Project	<b>IEEE 802.16 Broadband Wireless Access Working Group</b> < <a href="http://ieee802.org/16">http://ieee802.org/16</a> >	
Title	<b>Obtaining R-link Parameters during RS Network Entry</b>	
Date Submitted	<b>2007-11-11</b>	
Source(s)	Kanchei (Ken) Loa, Yi-Hsueh Tsai, Yung-Ting Lee, Hua-Chiang Yin, Shiann-Tsong Sheu, Youn-Tai Lee	Voice: +886-2-27399616 Fax: +886-2-23782328 <a href="mailto:loa@iii.org.tw">loa@iii.org.tw</a>
	Institute for Information Industry 8F, No. 218, Sec. 2, Dunhua S. Rd., Taipei City 106, Taiwan	
	[add other co-authors here]	
Re:	IEEE 802.16j-07/043: "IEEE 802.16 Working Group Working Group Letter Ballot #28"	
Abstract	This contribution proposes a scheme to obtain R-link parameters during RS network entry	
Purpose	Text proposal for 802.16j Draft Document.	
Notice	<i>This document does not represent the agreed views of the IEEE 802.16 Working Group or any of its subgroups. It represents only the views of the participants listed in the "Source(s)" field above. It is offered as a basis for discussion. It is not binding on the contributor(s), who reserve(s) the right to add, amend or withdraw material contained herein.</i>

# Obtaining R-link Parameters durin

Figure xxx—Obtaining and maintaining synchronization with R-MAP at a RS

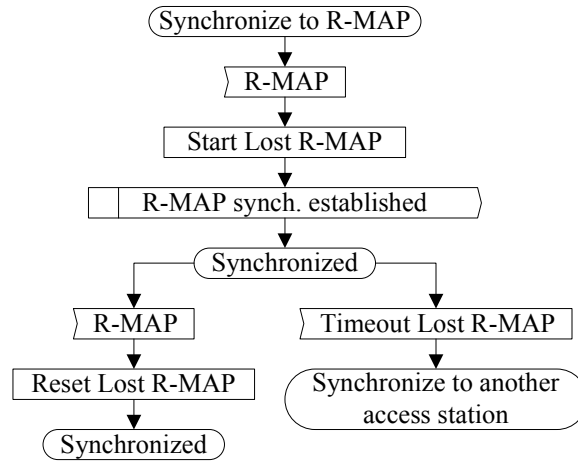
After registration, the non-transparent RS shall obtain the location of the relay zone containing the R-FCH through “Relay zone indicator (DIUC = 13)” in the DL-MAP message in the access zone. Afterward, the RS shall decode the R-FCH and then the R-MAP message within the relay zone. In order to obtaining R-link parameters, the RS shall first search for the R-MAP messages. Once the RS has received at least one R-MAP message and is able to decode the burst in R-link successfully, the RS will achieve R-link MAC synchronization. An RS MAC remains in synchronization as long as it continues to successfully receive the R-MAP for its channel. If the Lost R-MAP Interval has elapsed without a valid R-MAP message, an RS shall try to establish synchronization with another access station. The process of acquiring synchronization and maintaining synchronization are illustrated in Figure xxx. Afterward, RS should search for the RCD message broadcasted from the access station (see Figure yyy).

Figure yyy—Obtaining RCD message at a RS

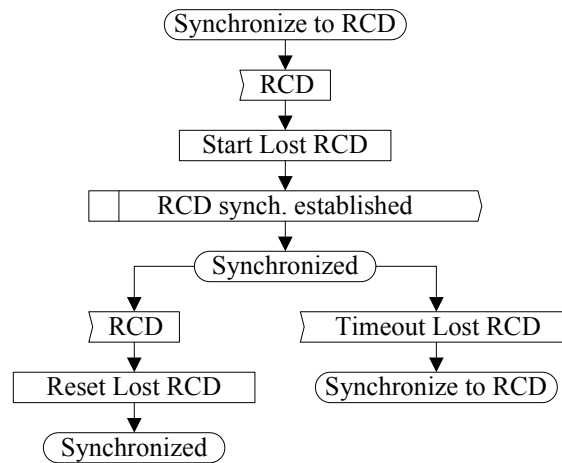
After registration, the transparent RS received the R-MAP message and then the RCD message in the access zone from the access station in order to obtaining R-link parameters (see Figure yyy).
